Item 4.8.2 of the provisional agenda

## Proposal for the 06 series of amendments to UN Regulation No. 78 (Braking of Category L vehicles)

### Submitted by the Working Party on Automated/Autonomous and Connected Vehicles\*

**Model A**

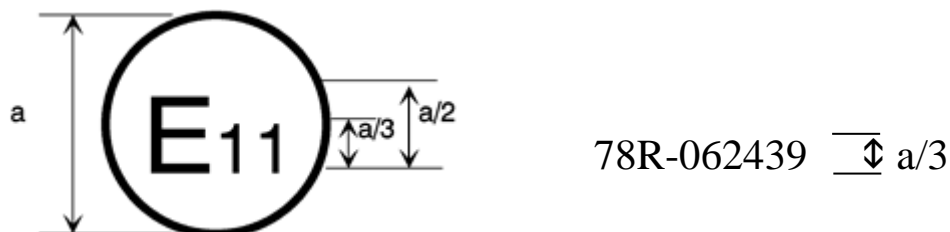
Annex 2, amend to read:

The above approval mark affixed to a vehicle<sup>1</sup> shows that the vehicle type concerned has, with regard to braking, been approved in the United Kingdom (E 11) pursuant to UN Regulation No. 78 under approval number 062439. The first two digits of the approval number indicate that UN Regulation No. 78 already included the 06 series of amendments when the approval was granted.

**Model B**

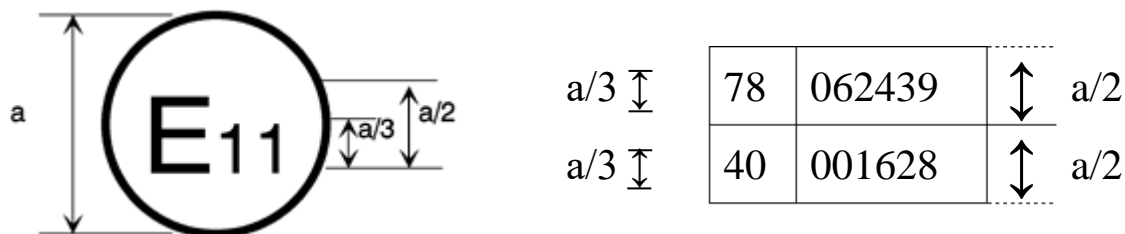
The above approval mark affixed to a vehicle shows that the vehicle type concerned has been approved in the United Kingdom (E 11) pursuant to UN Regulations Nos. 78 and 40.<sup>2</sup> The first two digits of the approval numbers indicate that, at the dates when the respective approvals were granted, UN Regulation No. 78 included the 06 series of amendments but UN Regulation No. 40 was still in its original form.”
